LOT GRADING REVIEW

LOT/BLK. NO.(S) LOT 85

LECCO RIDGE DEVELOPMENTS INC.

LOT No. 85

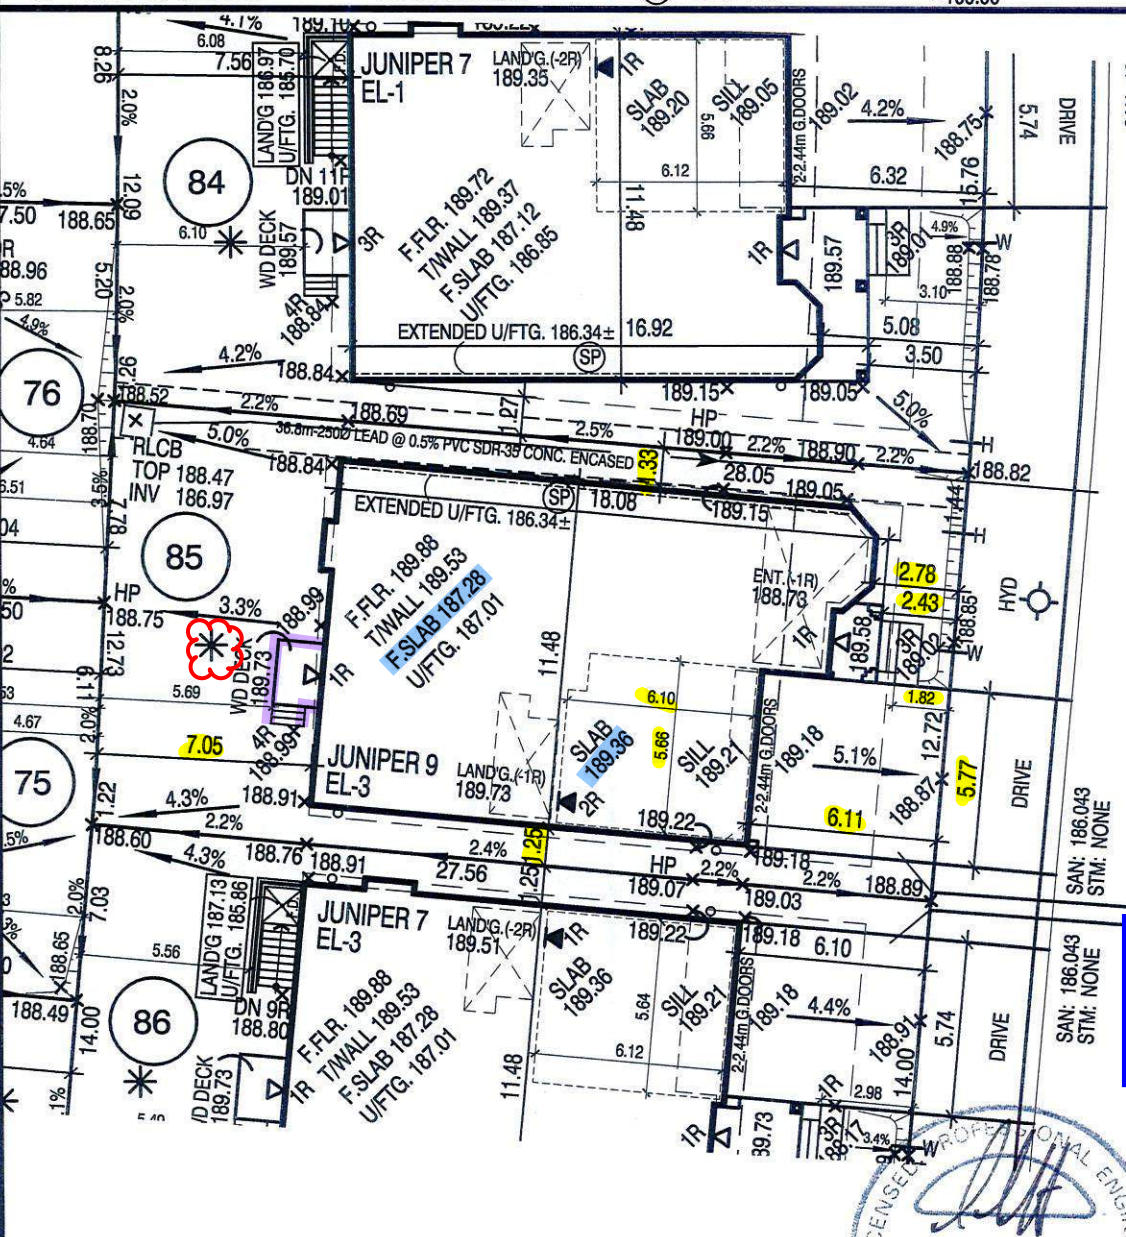
45 Min FRR

45 Min FRR w/NC Cladding

Guard/Handrail as per 9.8.

2.08 m Backfill height as per 9.15.

Siting to be read in conjunction with reviewed main model drawings
